CERTIFICATE OF APPROPRIATENESS

Property: 1008 E 14th Street, Lot 2, Block 119, North Norhill Subdivision. The property includes a historic 1,909 square foot, one-story single-family residence situated on a 5,250 square foot (50' x 104') interior lot.

Proposal: Alteration – Replace two 1-over-1 original wood sash windows that have been relocated to a rear addition with two 1-over-1 sash windows. The windows have been determined to be damage past the point of repair by staff and a historic window repair specialist. The two windows will be replaced with either wood or composite replacement sashes. The property owner originally proposed a wholesale replacement of the original wood sash windows. The owner had the widows inspected by a historic window repair specialist and will have each of the original sash windows repaired for less than the cost of a replacement window.

WEST SIDE ELEVATION

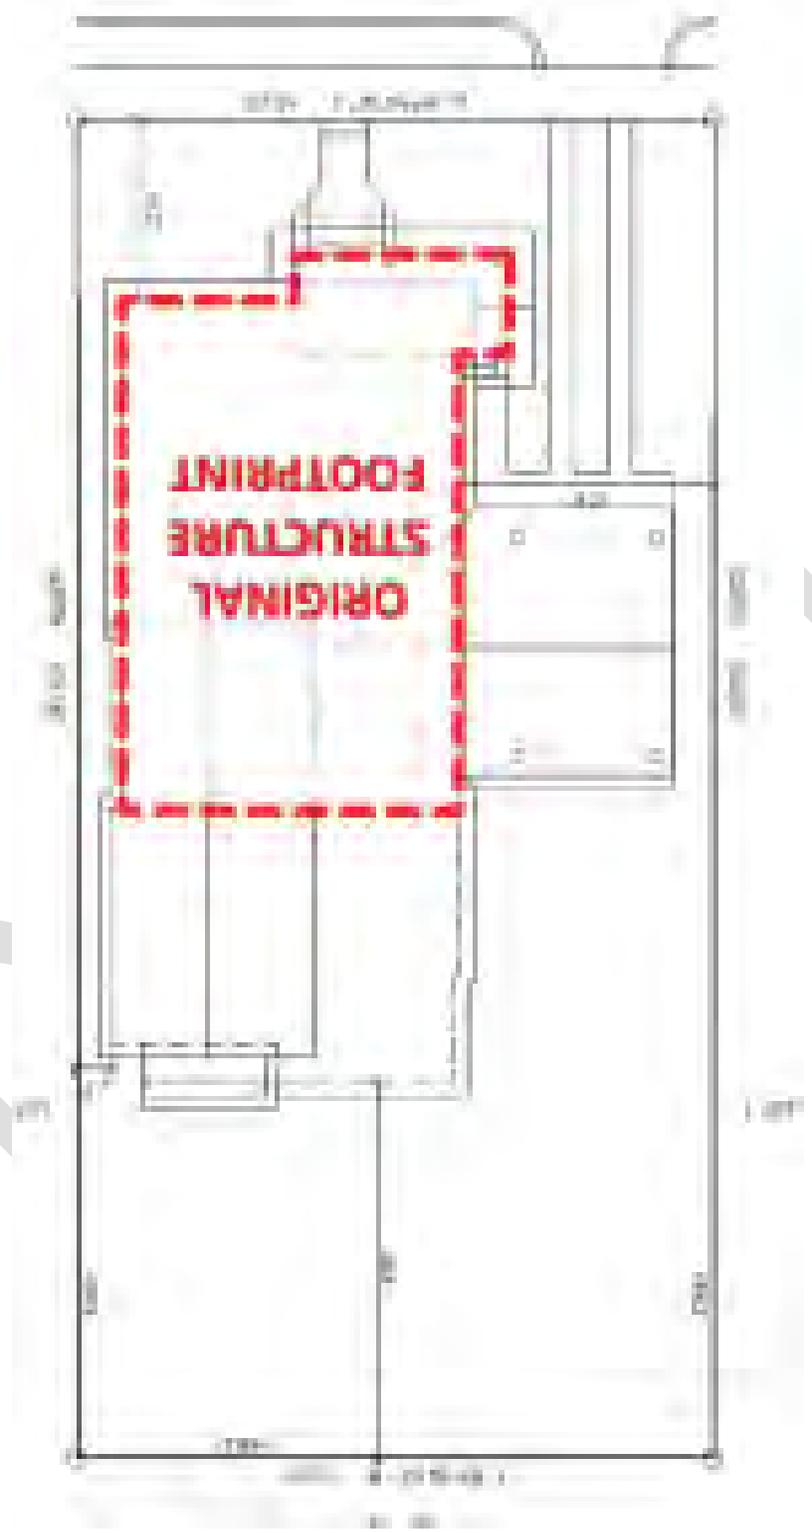
Windows/Doors: Replace two original 1-over-1 wood sash windows located on at the rear of the west elevation of an existing addition with two 1-over-1 wood or composite sash windows. It has been determined that the windows are damaged past the point of repair. The window opening will not be modified.

Recommendation: Approval
